Staff Report

Infill Housing Design Review Committee

File Number: 2-G-25-IH

Location: 3335 Divide St. **Parcel ID** 81 P B 003
Zoning: RN-2 (Single-Family Residential Neighborhood)
District: Lonsdale Infill Housing Overlay District

1"=10'-0"
 Sheet Number
A-1
 Of Sheets

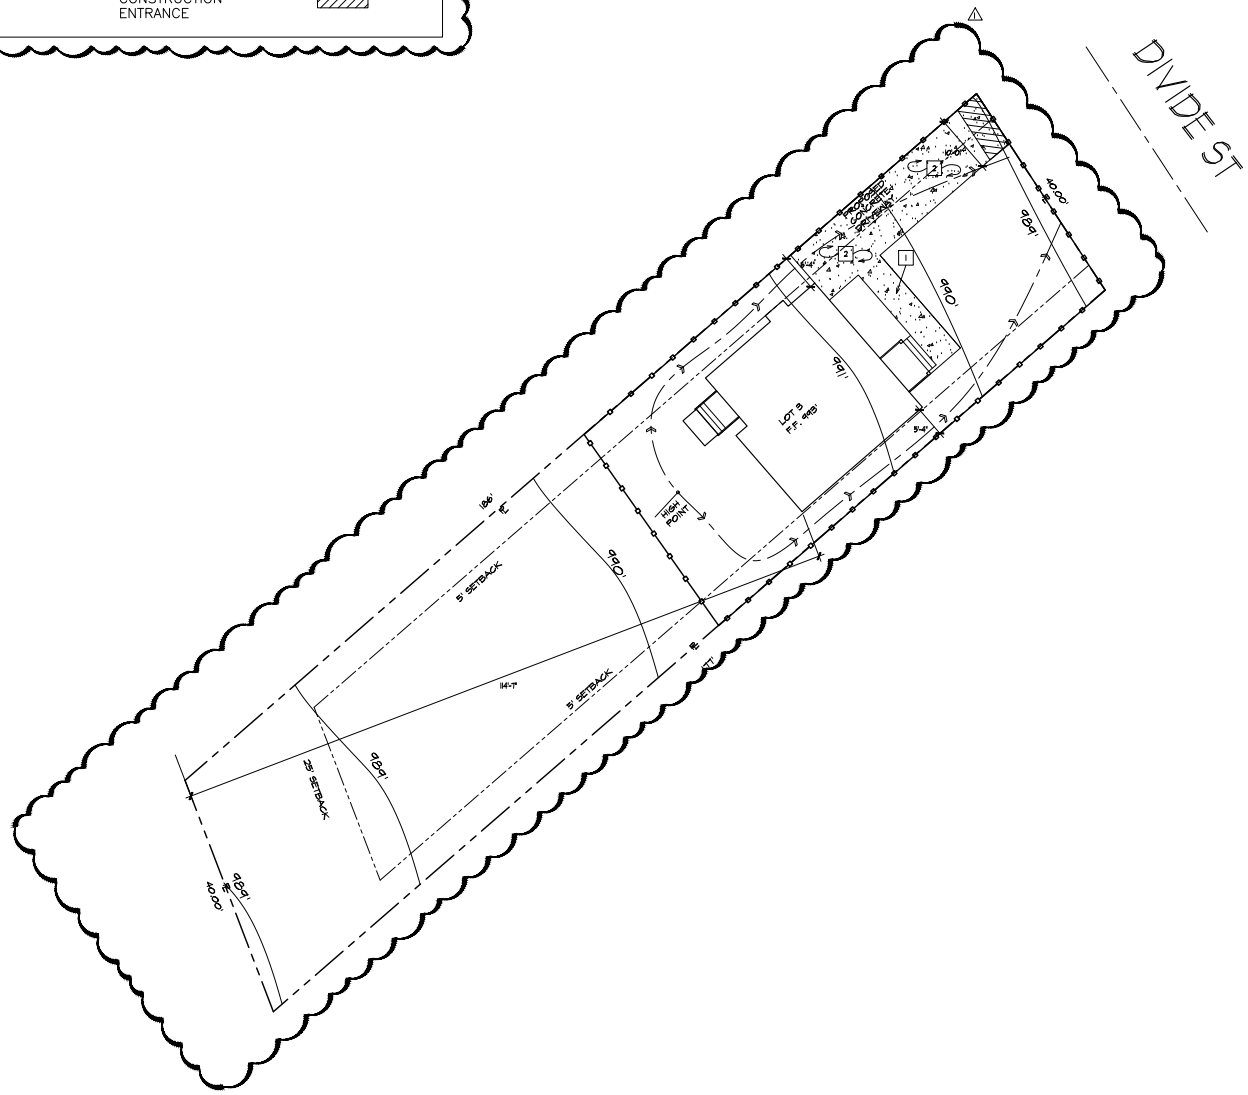
1. The front setback of the house is not specified. The final site plan should be revised so that the front walkway connects to both the street and the driveway.

3. Infill Housing design guidelines recommend that on lots without alleys, new driveways should be at least 20' behind the front façade of the infill house with access limited to one lane between the street and the front façade. Parking is a concrete pad located in front of the house and accessed via a driveway from Divide Street. Parking should be revised to avoid the front yard.

9. The final site plan should be revised to include a native or naturalized shade tree in the front and back yards.

Sheet Number: **A-2**

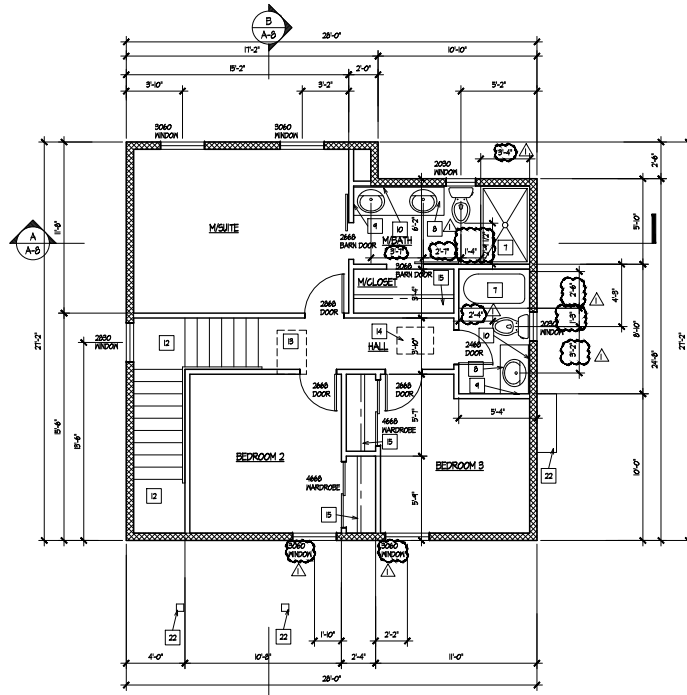
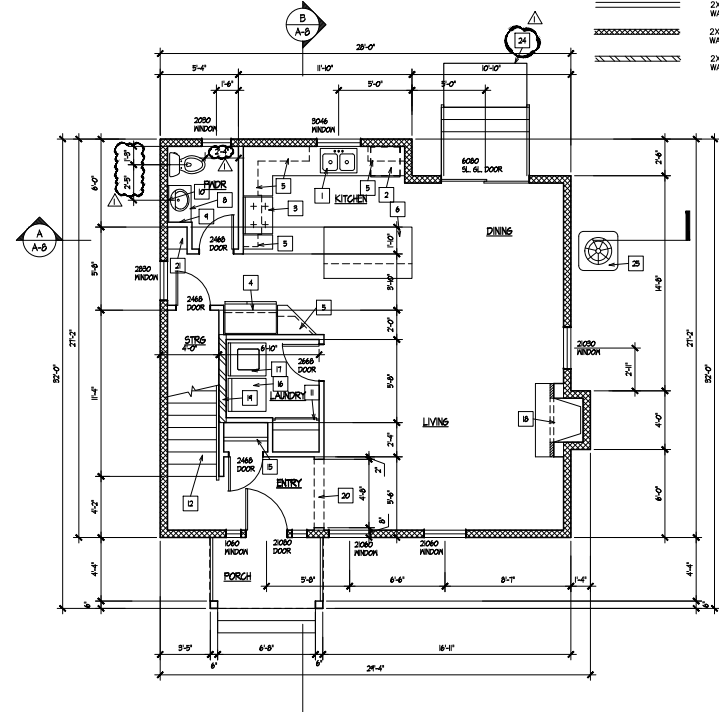
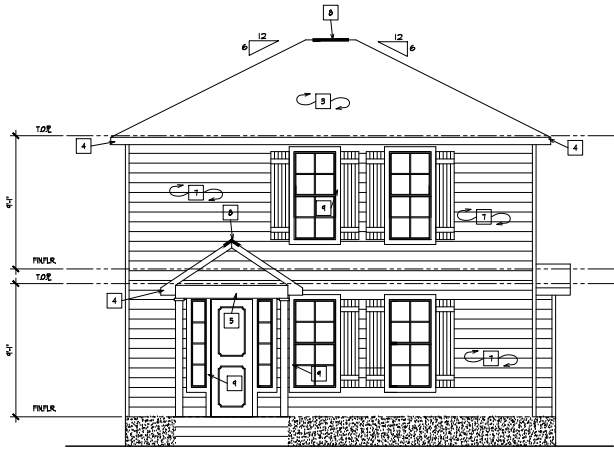
2. The block to receive new construction lacks significant context, as almost all the houses on the street are infill construction, interspersed with Minimal Traditionals and vacant lots . The 28' wide by 27'-2" deep house is not proportionate to the other houses on the block. The infill houses are rectangular in plan and are approximately 28' wide and 40' deep or 44' wide and 28' deep, and most nearby houses on 40' wide lots range in width from 16'-25.' The house also does not meet the minimum side setbacks required by the base zoning, so a variance would be required if this plan moves forward, and the rear setback requirements would allow for a house with a narrower width and larger depth.

5. The house features a 6'-8" wide, 4'-4" deep front porch recessed under a front-gable roof and supported by two square wood posts. Guidelines state that front porches should be proportional to other houses on the block and at least 8' deep. The porch depth should be revised to at least 8', and the porch width should be increased to be proportional to the other houses on the block.

FRONT ELEVATION

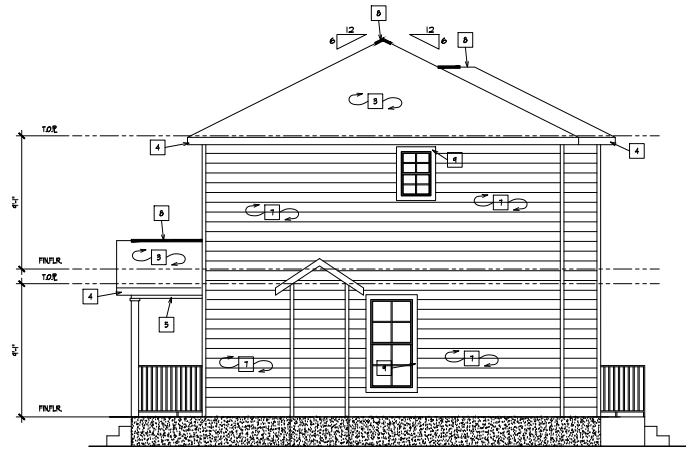
4. The two-story, three-bay façade is not similar in scale and height to the context, which almost exclusively features one-story houses with balanced façades.

6. Guidelines recommend window and door styles be similar to historic houses on the block, with similar placement and ratio of solid to void. The façade should be revised to avoid the half-shutter on the left first story window. The 4/4 single-hung windows are compatible with the 6/6 single-hung windows on most houses in the block, and the façade and rear elevations feature a sufficient ratio of solid to void. However, the house features five different window sizes, and the windows are placed at different heights on the side elevations, leaving large swaths of siding. The window sizes and placement should be revised to be more cohesive. The paneled door flanked with sidelights is appropriate.

7. The 6/12 roof pitch is the minimum typically approved for Infill Housing.
8. The asphalt shingles and horizontal vinyl siding meet the design guidelines, but the siding should be clapboard-style with an overlap instead of Dutch lap or flush panel siding. The foundation appears to be a concrete slab, which should be clad in stucco or parge-coated to meet the design guidelines.
